Iowa Department of Transportation
Highway Division

STANDARD DESIGN - 40' ROADWAY, 3 SPAN BRIDGES

ROLLED STEEL BEAM BRIDGES

RS40-017-10

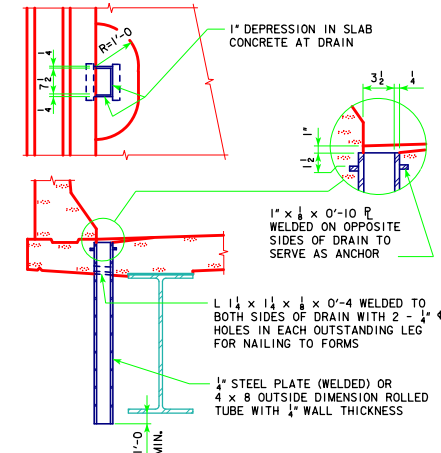
REVISED 10-11 - THE DRAIN EXTENSION BELOW THE BEAM WAS EXTENDED TO A 1'-0" DISTANCE. THE DATA FOR ONE DRAIN QUANTITIES WERE ADJUSTED FOR THE ADDITIONAL DRAIN LENGTH.
